UNITED STATES PATENT AND TRADEMARK OFFICE

| 10/578,854 | 05/11/2006 | Herbert Brunner | 12406-187US1 P2003,0931 U | 3209 |

| Office Action Summary | Application No. 10/578,854 | Applicant(s) BRUNNER ET AL. | |

FIG. 2

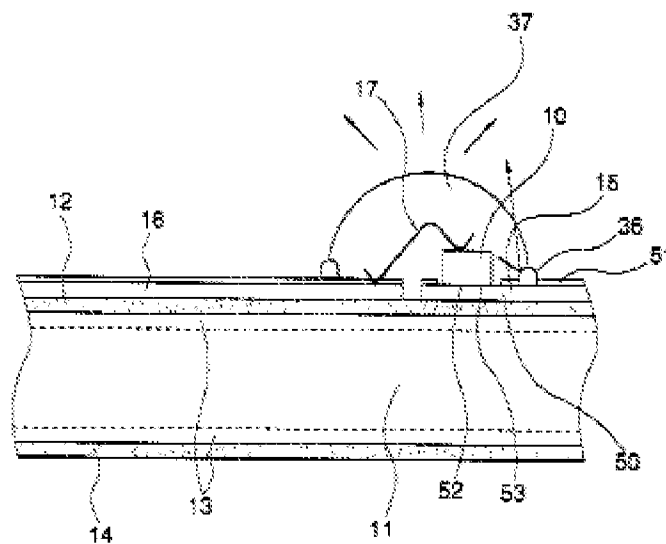
9. **With respect to claim 1**, Sakamoto (e.g. Figure 2) teaches a radiation-emitting and/or radiation-receiving semiconductor component comprising:

- A radiation-emitting and/or radiation-receiving semiconductor chip 10;
- A molded plastic body 37, ***made of a silicone molding compound*** (column 7, lines 48-51), which is at least partially transmissive to an electromagnetic radiation to be emitted and/or received by the semiconductor component (column 7, lines 44-49) and by which the semiconductor chip 10 is at least partially overmolded; and

- External electrical leads (15, 16) that are electrically connected to electrical contact areas of the semiconductor chip (column 5, lines 56-67),
- Wherein the semiconductor chip is mounted on a flexible lead frame (column 6, lines 47-50)

Sakamoto fails to teach that the flexible lead frame comprises *a carrier film that comprises at least a plastic film and a metal film, and wherein the plastic film has an opening and the semiconductor chip is positioned in the opening and directly contacts the metal film.*

With respect to claim 39, Sakamoto (e.g. Figure 2) teaches that the molded plastic body is formed of a single piece of plastic.
